PROJECT: Summerlin West V25 - Scurry Bend Drive Improvements

CITY OF LAS VEGAS INTER-OFFICE MEMORANDUM		DATE: June 3, 2021
TO: Land Development Services Department of Building & Safety		FROM: Albert Sung, P.E. Flood Control Project Engineer Department of Public Works
SUBJECT:	Drainage Study for:	COPIES TO:
Summerlin West V25 - Scurry Bend Drive Improvements (from Sunset Run Dr. to Lake Mead Blvd.)		Atkins
Cross Streets:	Scurry Bend Drive. & Lake Mead Boulevard	Howard Hughes Company, LLC
File Number:	F:\Depot\DSMemos\DS5427C.doc	Bart Anderson, P.E., DevCo
Parcel Number:	137-15-801-002 & more	
Zoning Action:	N/A	
FEMA Flood Zone	YES NO X	
Proposed Storm Drain	YES X NO

Addendum #2

**RE: ADDENDUM #2 TECHNICAL DRAINAGE STUDY FOR SUMMERLIN WEST VILLAGE 25
SCURRY BEND DRIVE – SUNSET RUN DRIVE TO LAKE MEAD BOULEVARD**

DESIGNED BY: B. MOCHTYAK
DRAWN BY: K. HENDRY
CHECKED BY: N. BARCOS
DATE: MAY, 2021
DRAWING NO.: 14/42
JOB NO.: 100069098

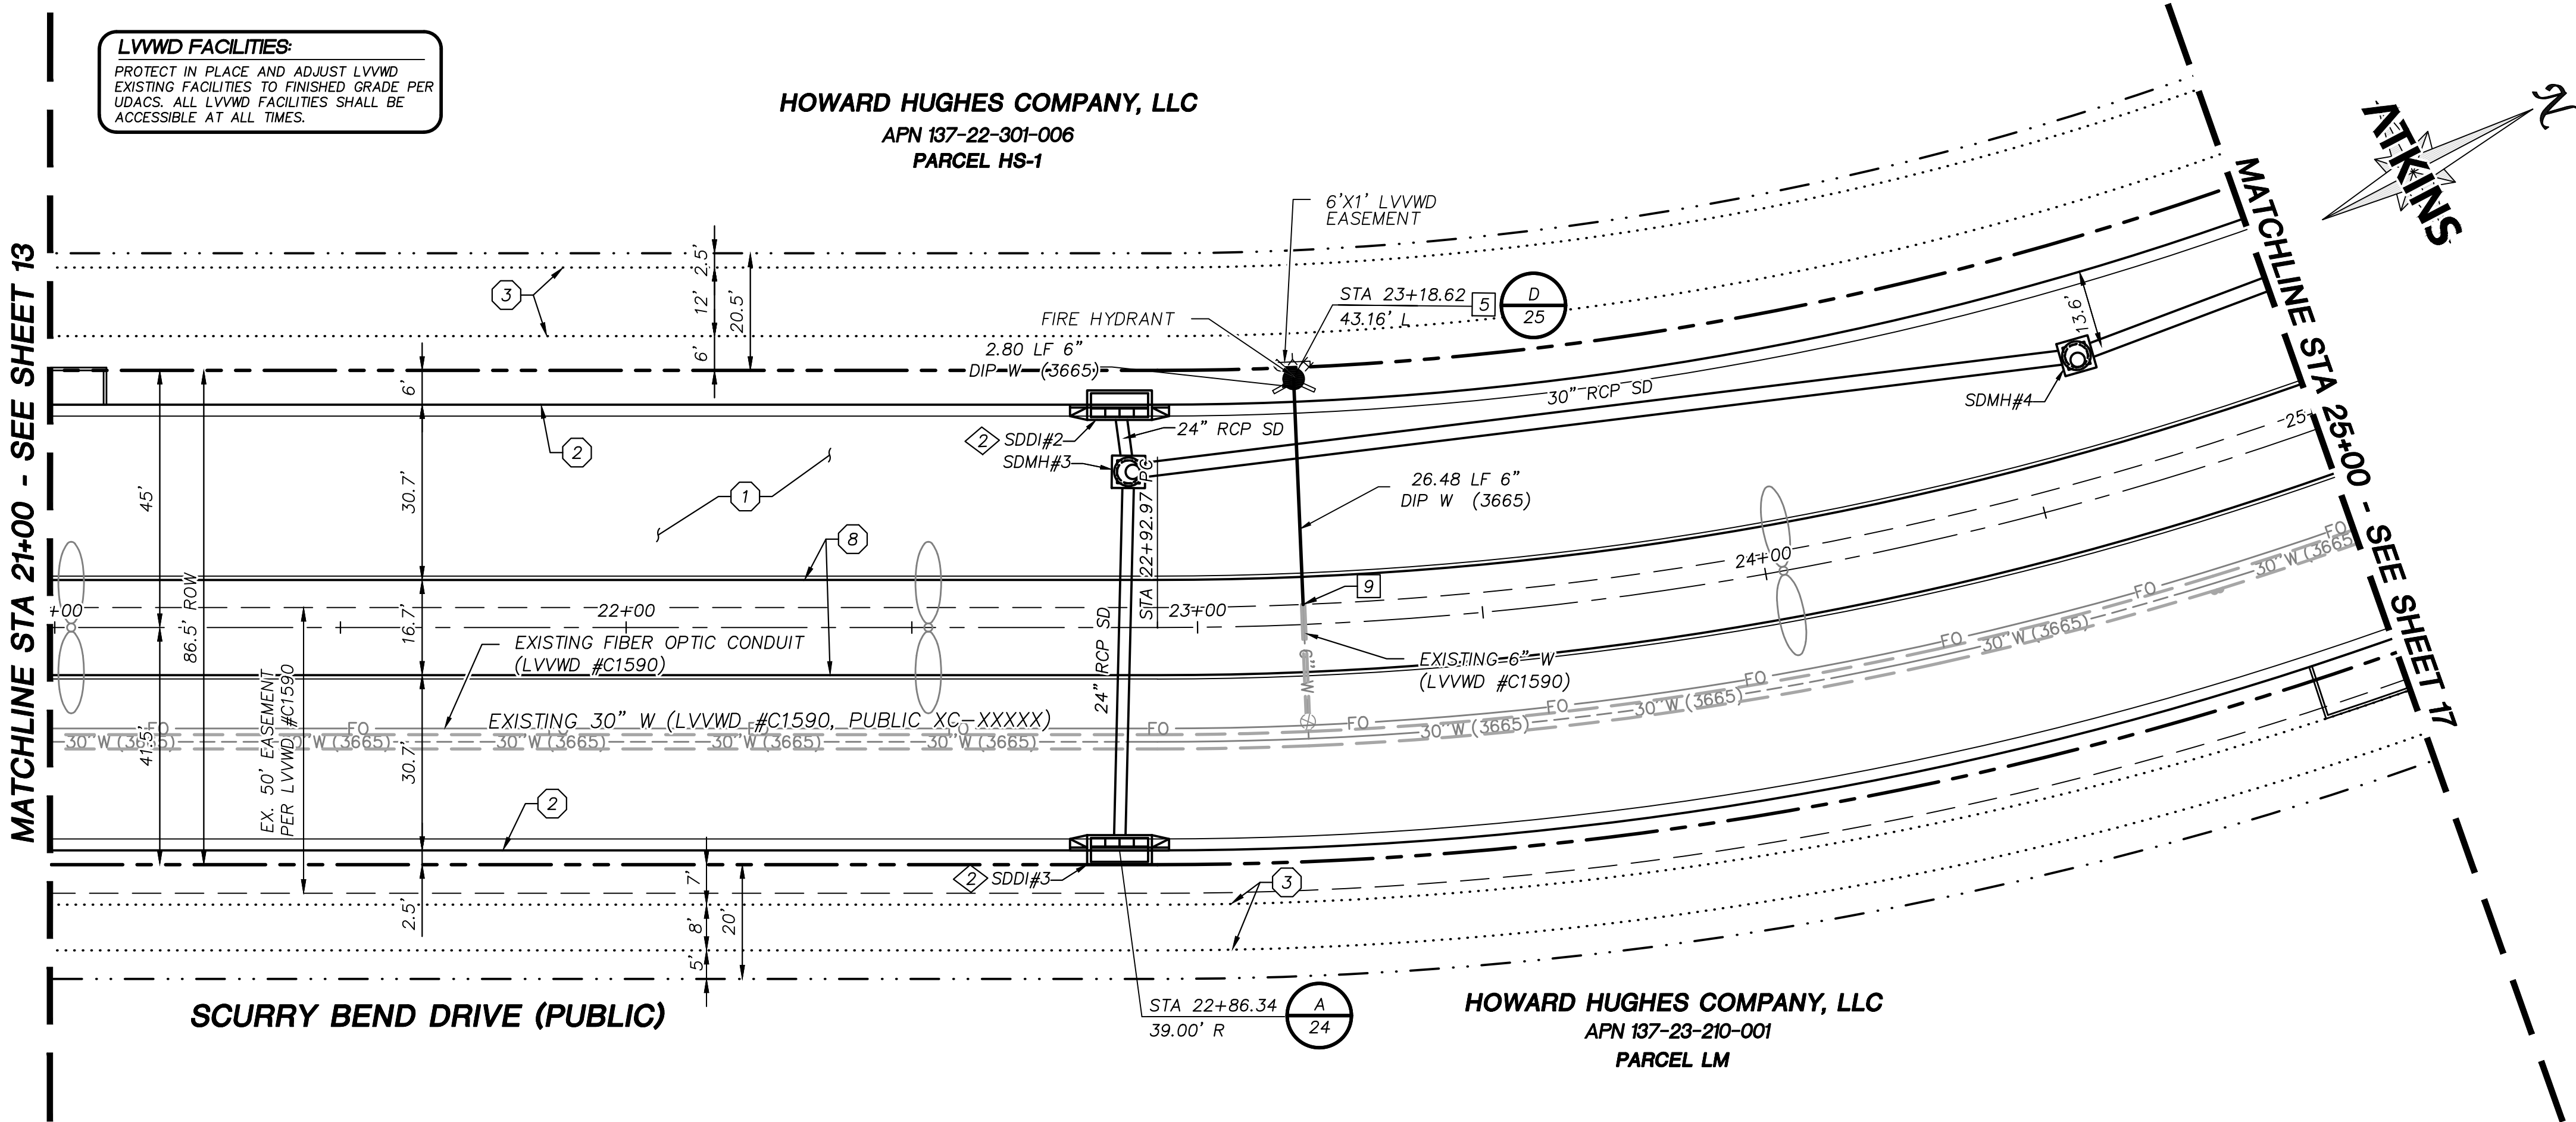
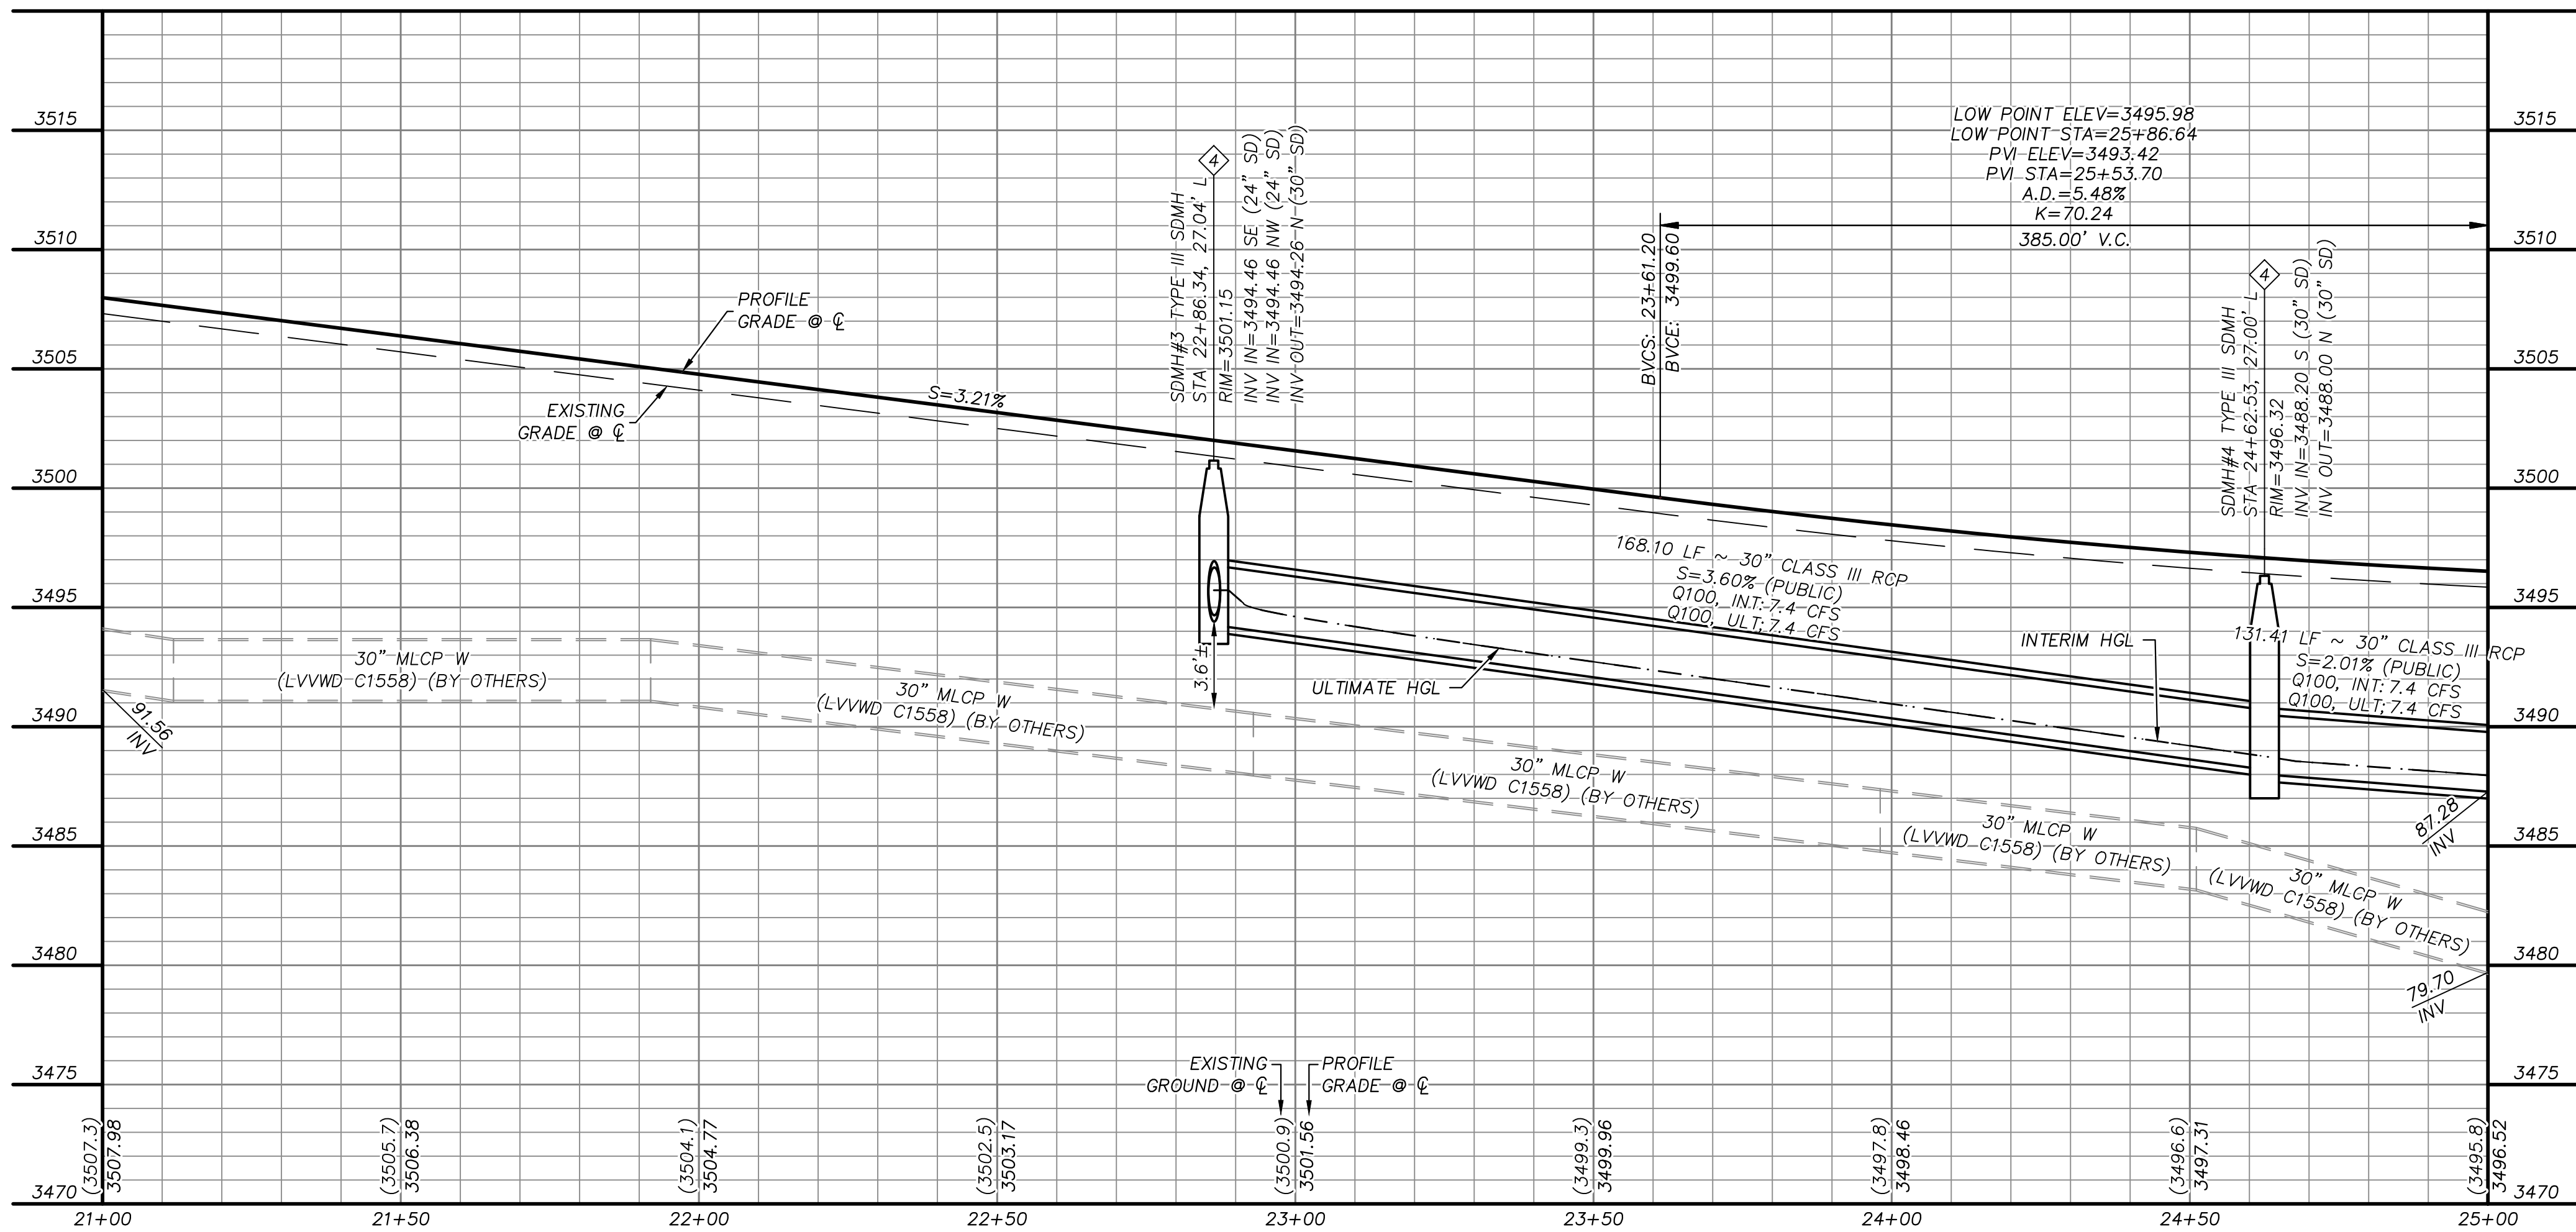
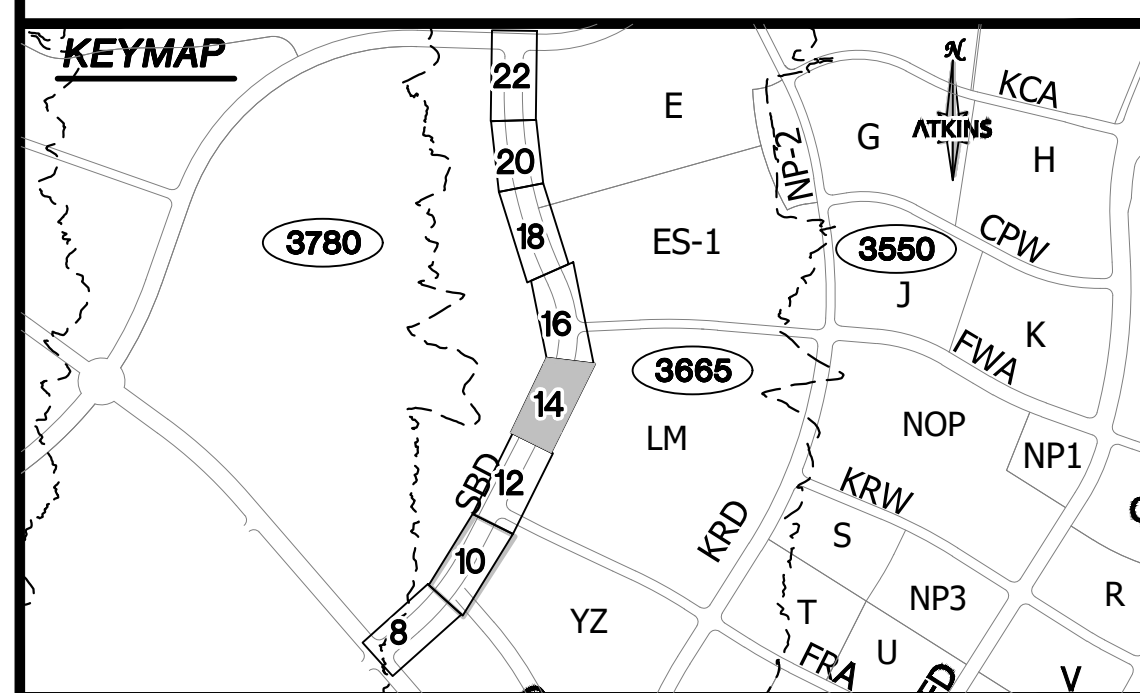
Comment #4: Previous Comment #13: *Sheet 14/42 and Sheet 15/42: The proposed 30"-RCP mainline is too close to the street curb. Maintain a minimum of 3'-clearance between the edge of the storm drain and the lip of the concrete gutter. Review and revise accordingly.*

Clearly label the 3'-minimum requirement on the plans at the tightest location in the next submittal.

Comment response: The improvement plans have been updated to provide dimensions of the clearance from the curb to the storm drain.
